RE: Uranerz Energy Corporation, Nichols Ranch ISR Project, NRC License SUA-1597, Docket No. 40-9067 (TAC J00726), Jane Dough Unit License Amendment Request

**INDEX SHEET FOR MINE PERMIT AMENDMENTS OR REVISIONS**

MINE COMPANY NAME: Uranerz Energy Corporation  
MINE NAME: Nichols Ranch ISR Project

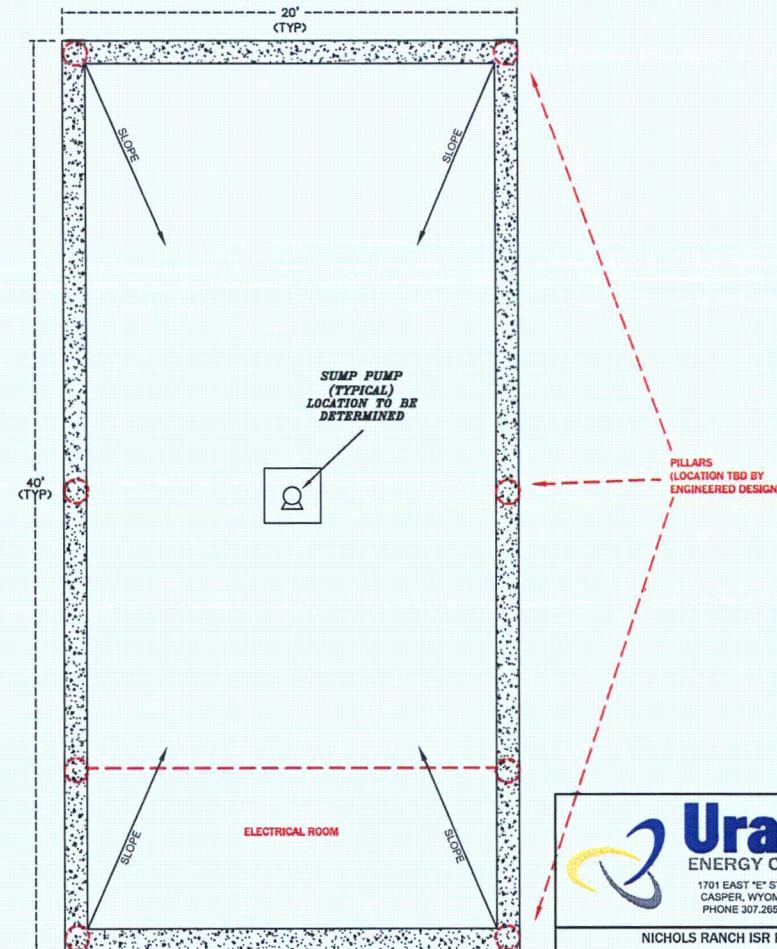
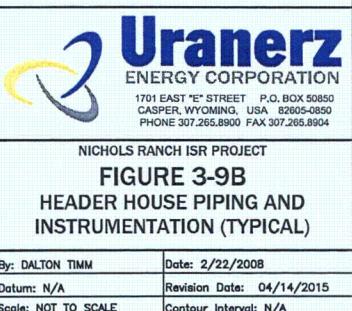
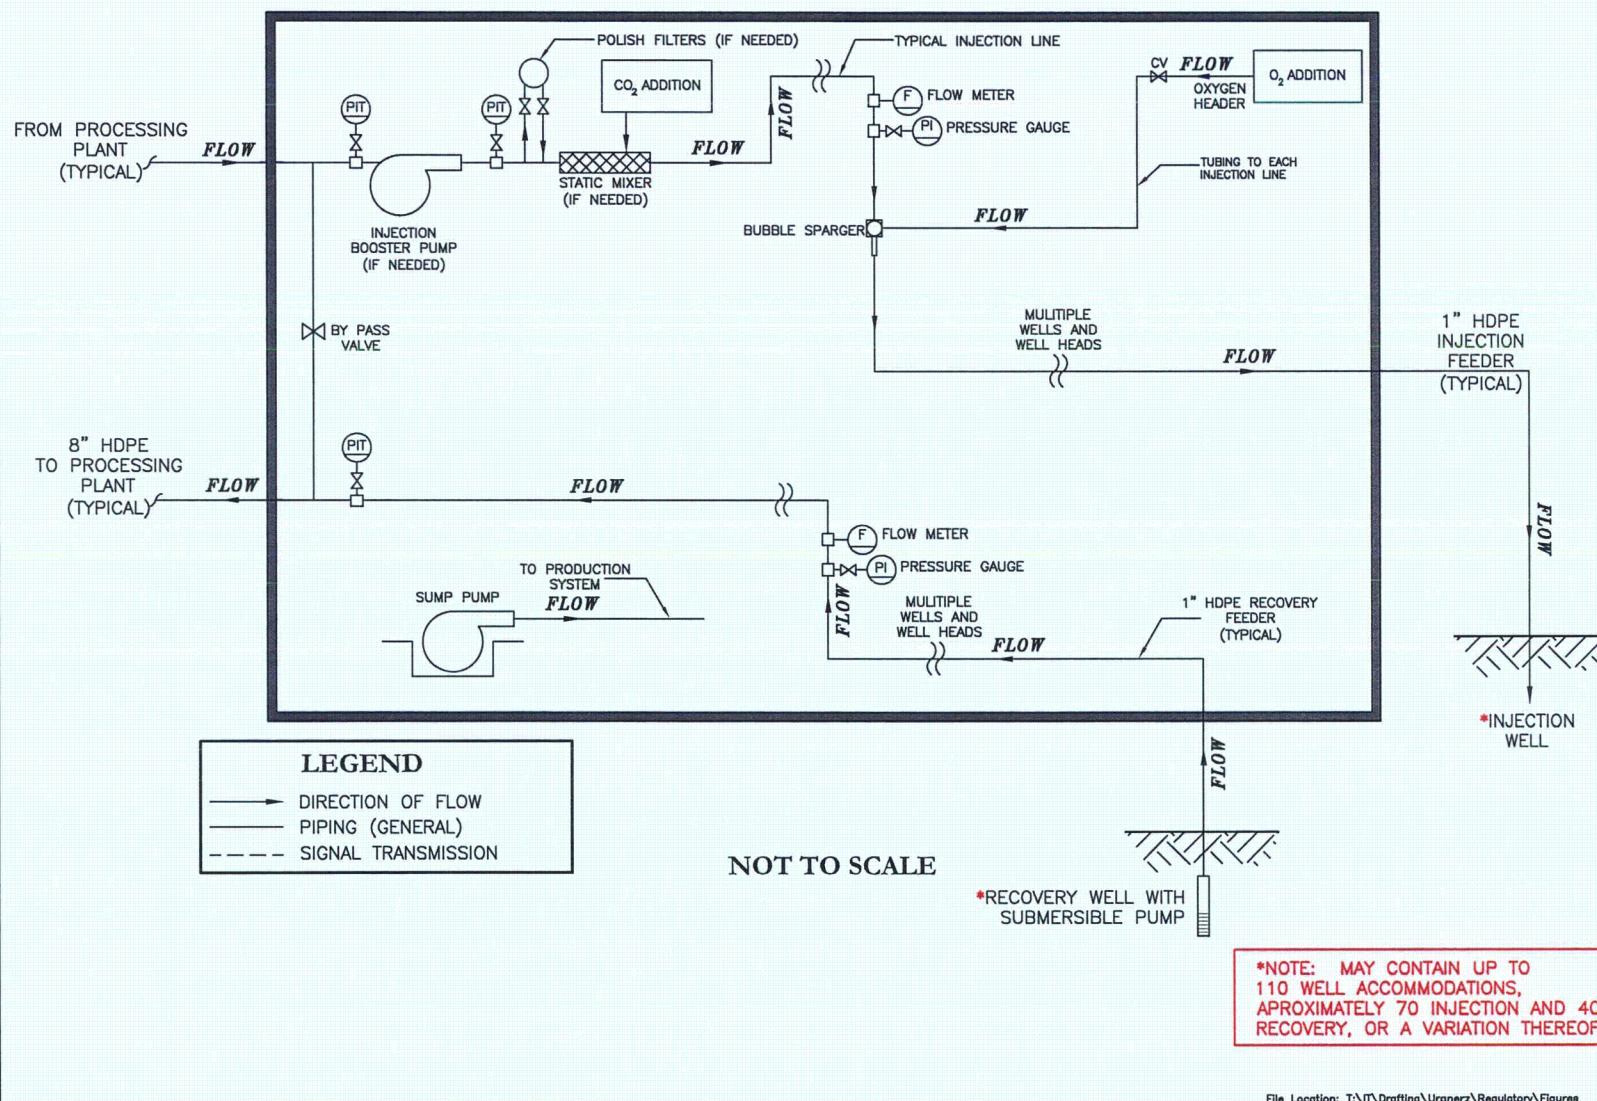
Depending on the oxidation requirement of the formation, the injection wells may be equipped with oxygen spargers so that each well can be controlled as to the amount of oxygen concentration it receives, or a header house oxygen manifold distributor will be installed. Header houses are small buildings that contain the manifolds with valves, piping, and instrumentation for injection and recovery wells. Each header house will contain approximately **110** well accommodations, but may contain more or less. **The typical header house design is shown in Figure 3-9A Header House Details (see map pocket), and the details of the piping and instrumentation for the header house is shown in Figure 3-9B Header House Piping and Instrumentation (see map pocket).**

The header houses will be metal buildings. **The dimensions for the header houses will be approximately 40 feet by 20 feet, but may be more or less. The terrain and logistics in the wellfield will determine which engineered foundation (e.g. pad, pillar, or basement) the header house will be built on. The foundations will be constructed of durable materials that meet engineering requirements or other suitable materials with sealed penetrations (as needed) to provide containment.** The foundation will have grating which will allow access to the sub floor containing valves and hose runs. **The floor will curb and/or slope to a sump with an automatic level control pump. The sump will pipe to the recovery system and will include check valves.** In header houses with basements the basement will contain the hose runs and injection and recovery lines. The header house may be designed to contain the electrical equipment in the same room with the piping or the electrical room may be attached to the main header house building and placed on concrete pillars that are buried underground for structural support.

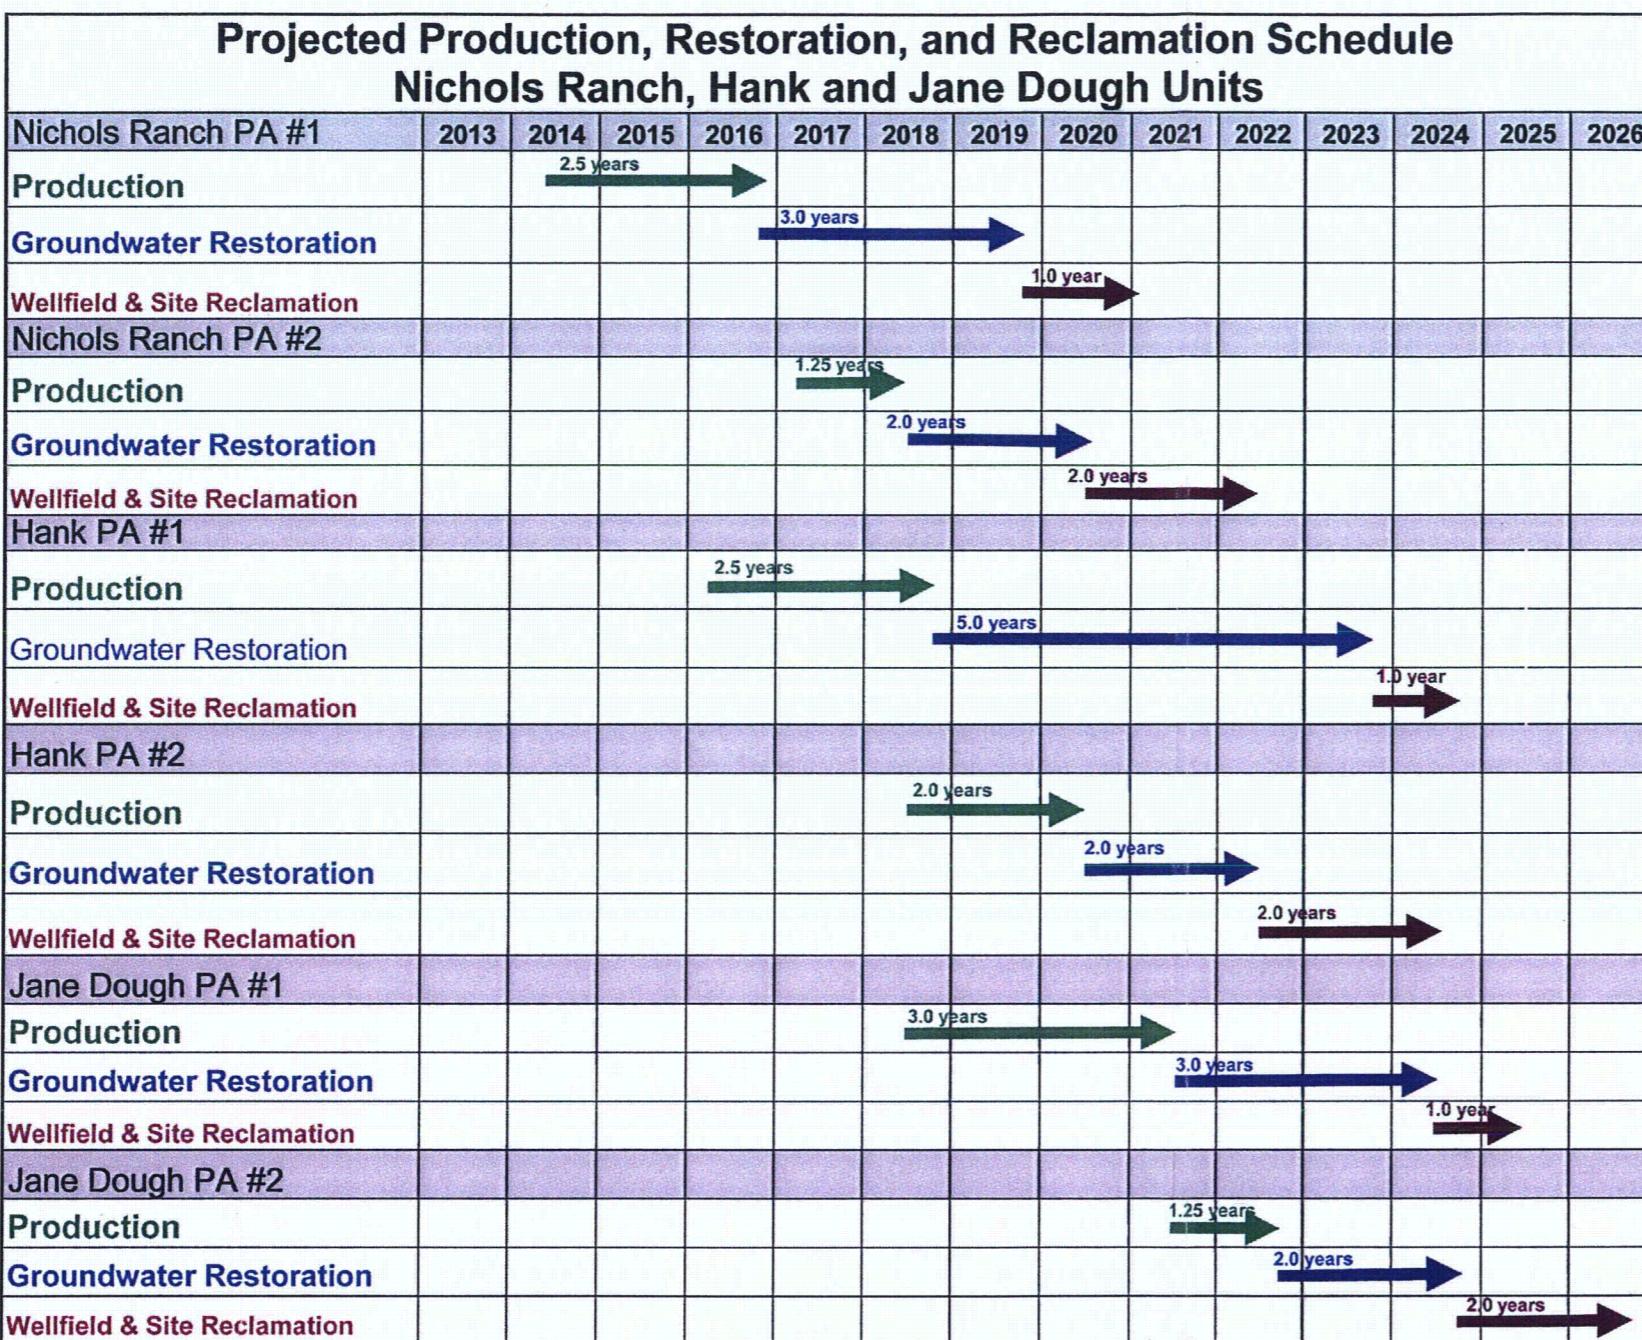
The amount of time for restoration shown in Figure 3-12 is based on the current estimate of deep disposal well capacity and the restoration methods outlined in Chapter 6.0 of the Technical Report. As stated in Chapter 6.0, Section 6.1, Uranerz will adhere to 10 CFR 40.42. When decommissioning and/or restoration begin, the NRC will be notified and a plan submitted for review or approval. If, at that time, groundwater restoration is estimated to take longer than 24 months based on items such as deep disposal well capacity, Uranerz will request an alternate schedule as allowed under 10 CFR 40.42(i).

FIGURE 3-13 NICHOLS RANCH & HANK ISR PROJECTS

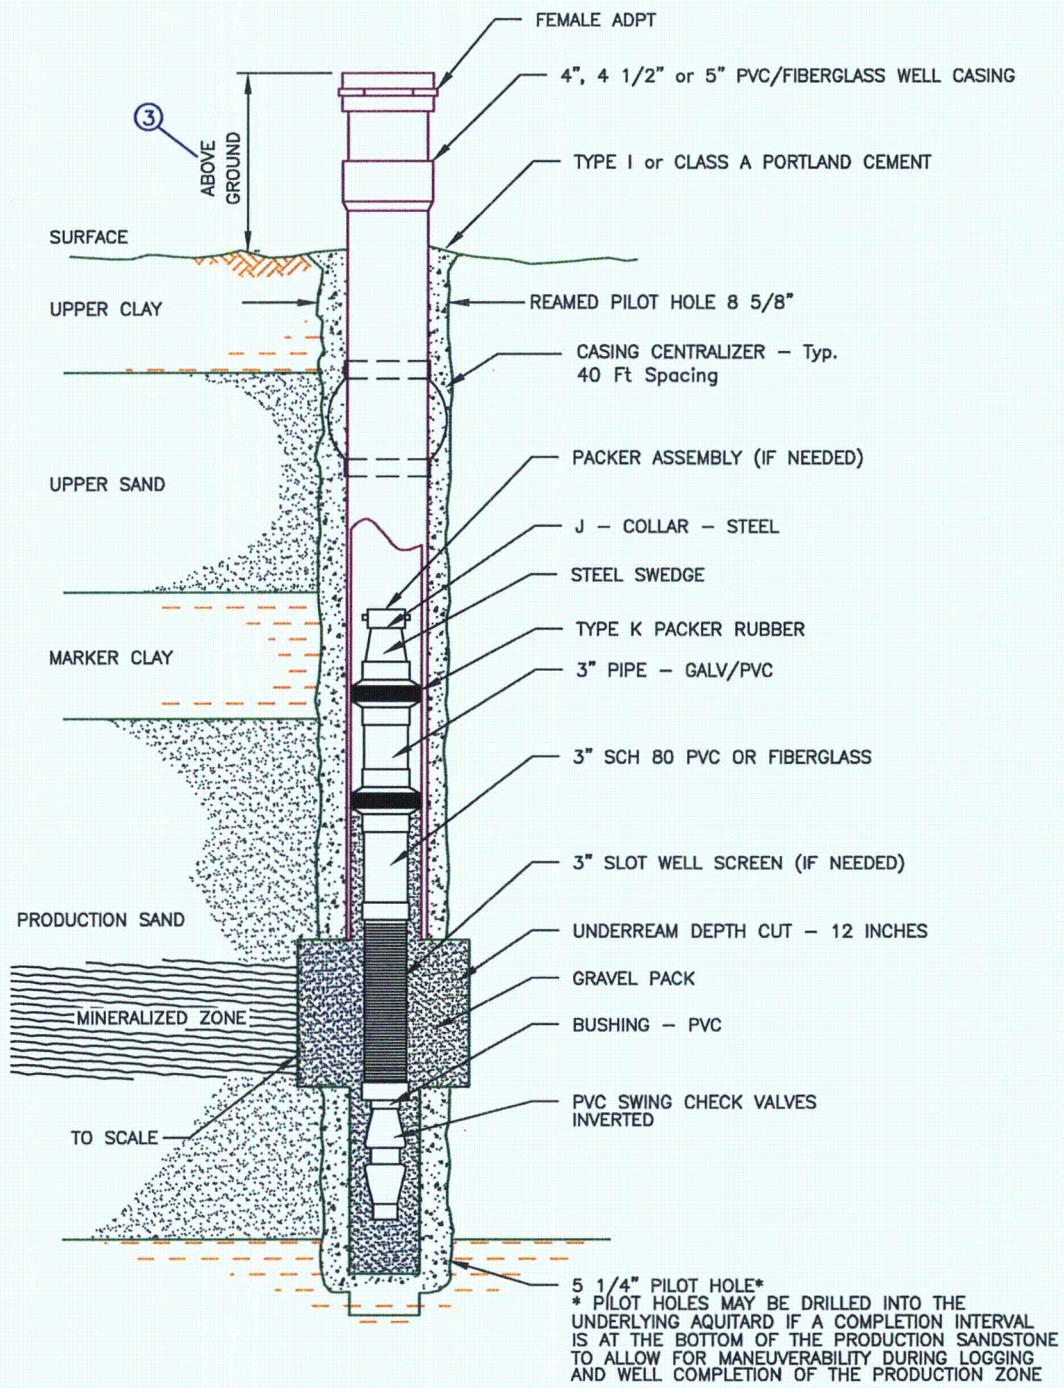
Typical well completion schematics for production wells (recovery and injection wells), and monitor wells are shown on Figures 3-13 (see map pocket) and 3-14 (see map pocket),
